**ADDENDUM
NO. 4**

**Greenfield Central High School Auditorium Renovation and
Addition – Bid Package No. 1
810 N. Broadway
Greenfield, IN 46140**

ADDENDUM NO. FOUR

C BALCONY SECTION C
1/2" = 1'-0"

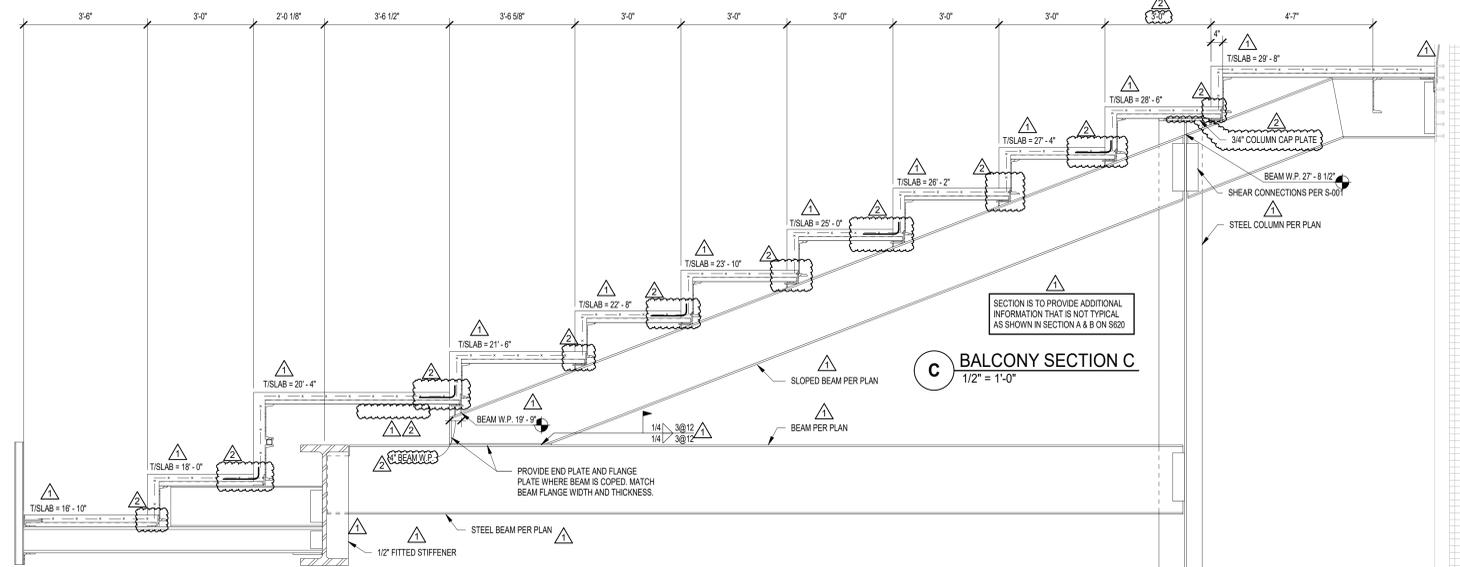
- b. NOTED THAT DETAILS 11 & 12 ARE NOT USED.
 - c. ADJUSTED DETAIL 13
- 10.S620 – FRAMING SECTIONS
 - a. ADDED NOTE TO DETAIL A
 - b. ADDED GRAPHICAL DETAILS AND DIMENSIONS TO DETAIL C

D BALCONY SECTION D
1/2" = 1'-0"

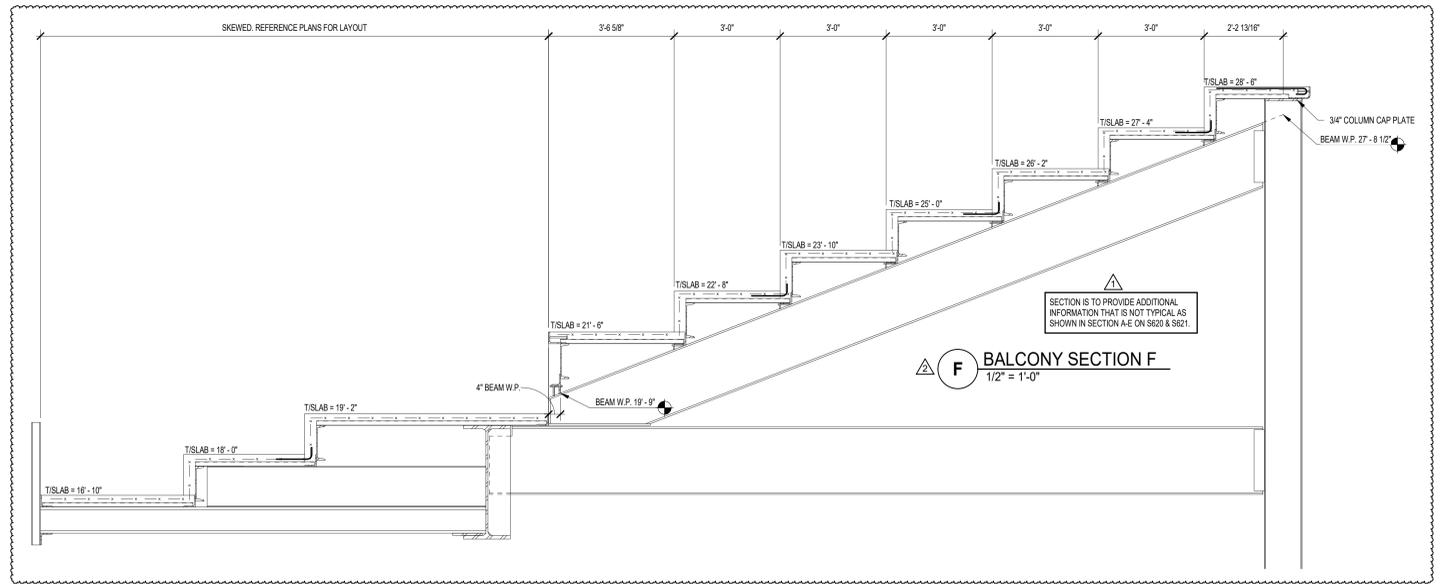
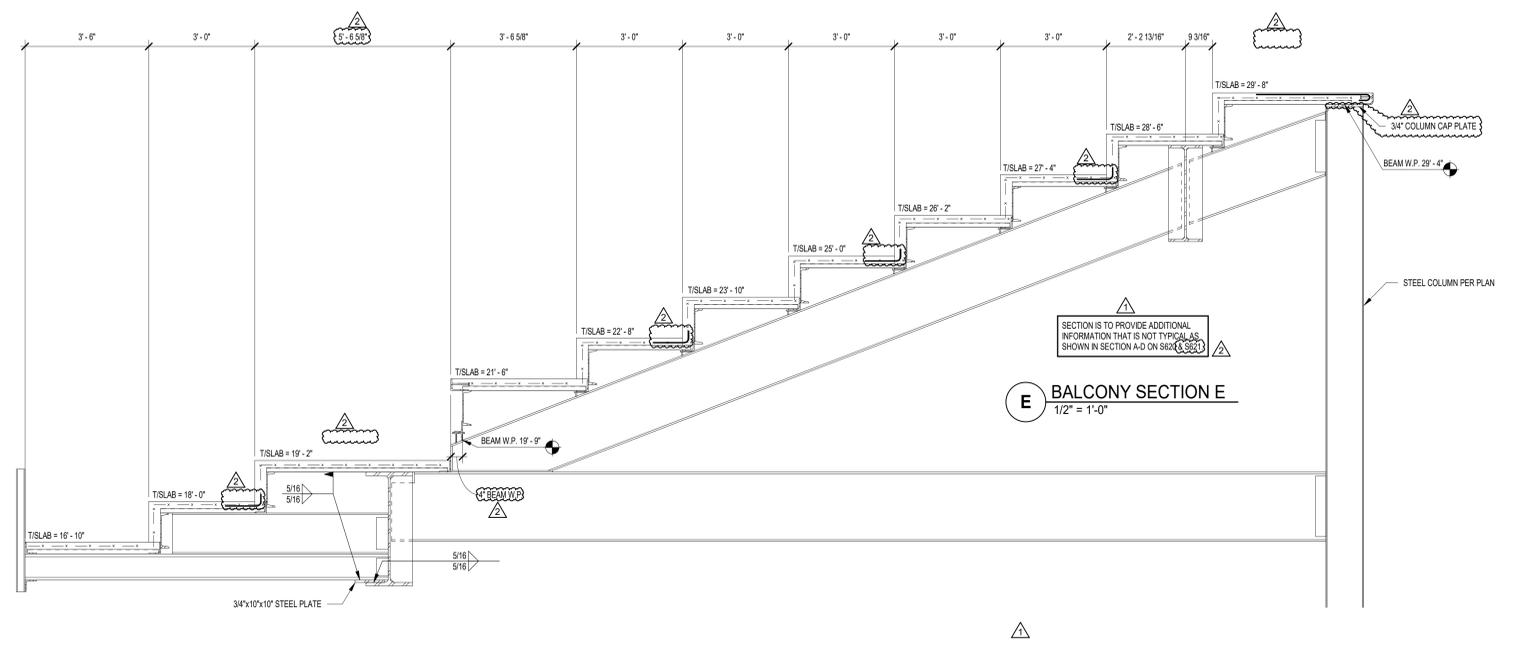
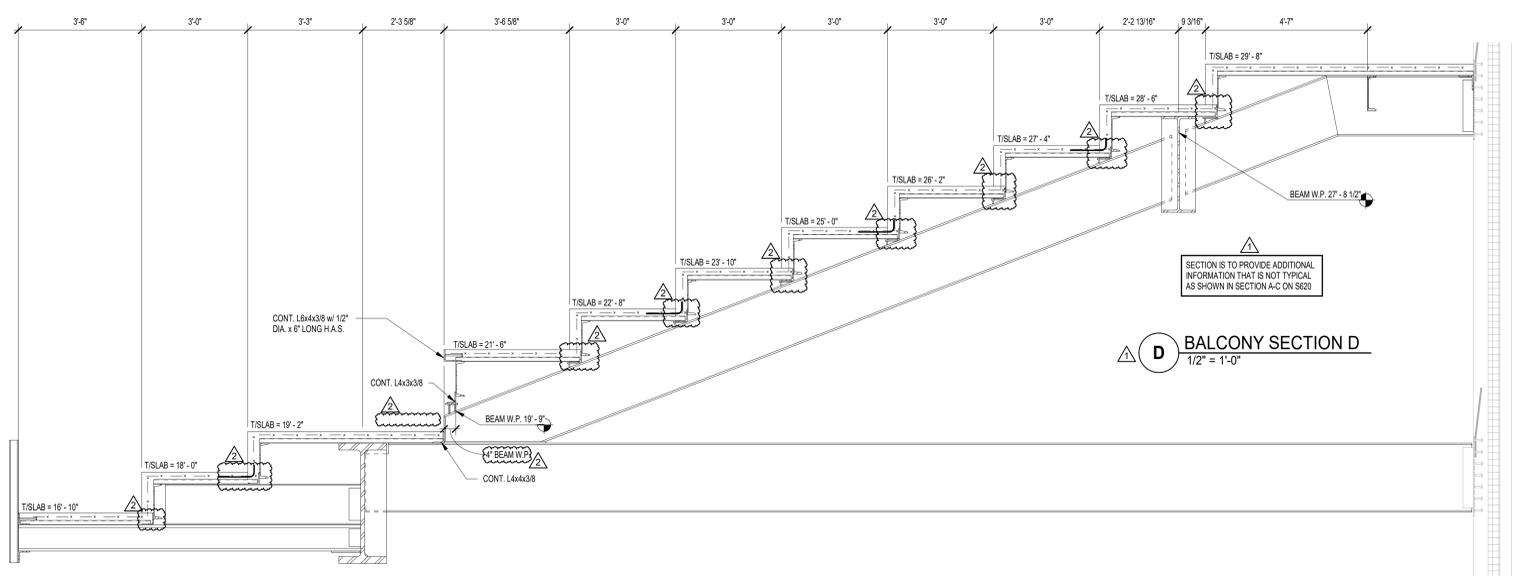
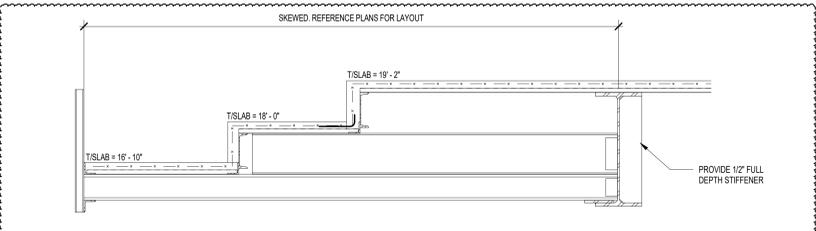
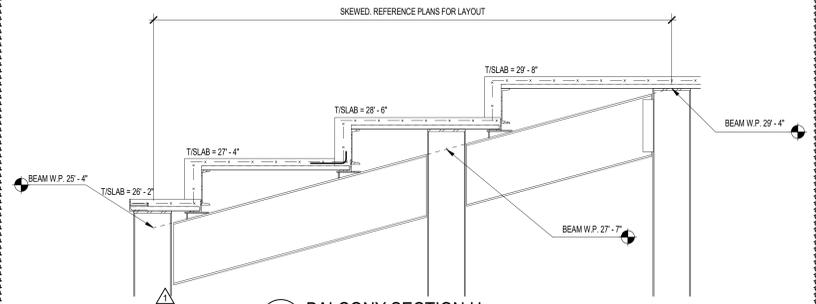
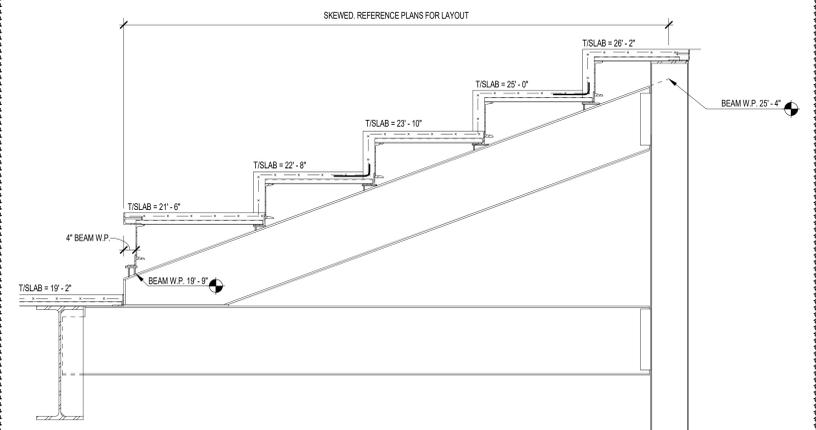
- 11.S621 – FRAMING SECTIONS
 - a. ADDED GRAPHICAL DETAILS AND DIMENSIONS TO DETAIL D-J
- 12.S622 – FRAMING SECTIONS
 - a. ADDED GRAPHICAL DETAILS AND DIMENSIONS TO DETAIL K-P

Q BALCONY SECTION Q
1/2" = 1'-0"

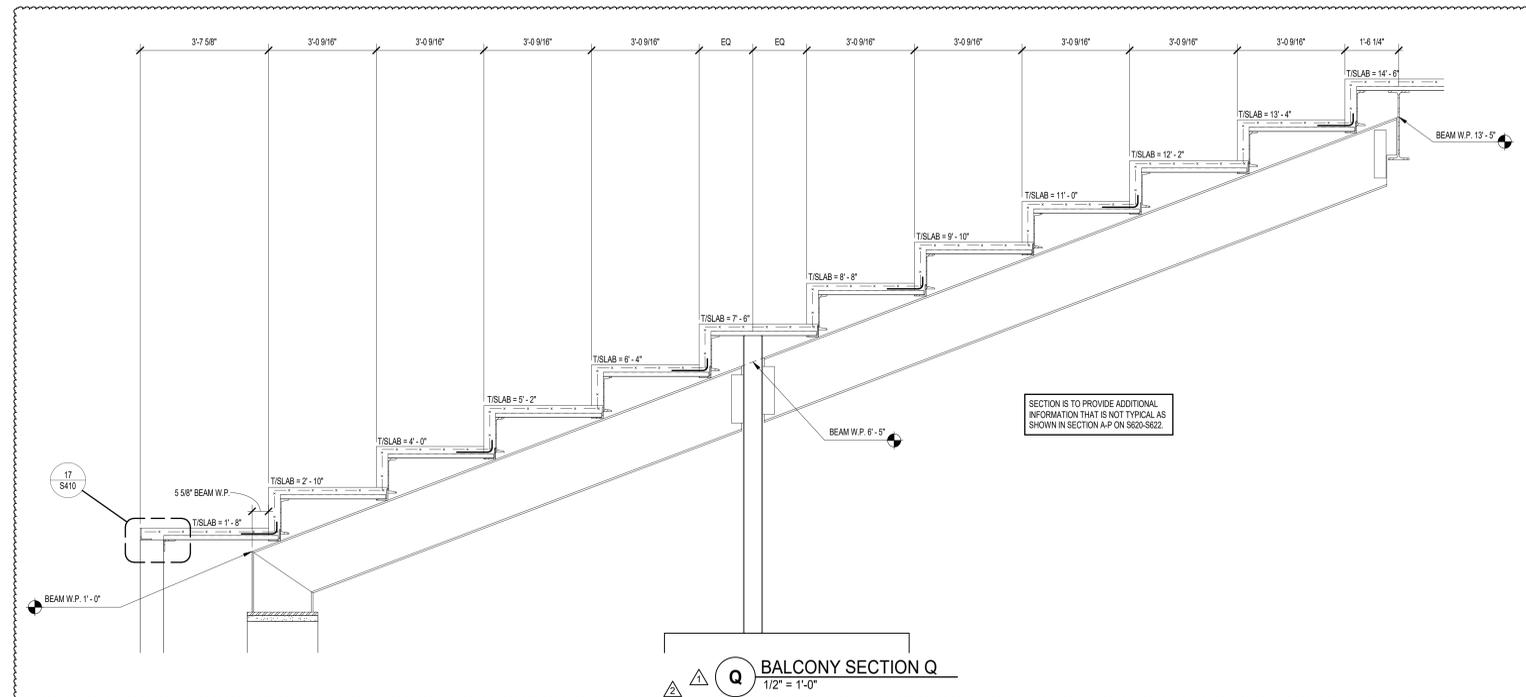
- 13.S623 – FRAMING SECTIONS
 - a. ADDED GRAPHICAL DETAILS AND DIMENSIONS TO DETAIL Q
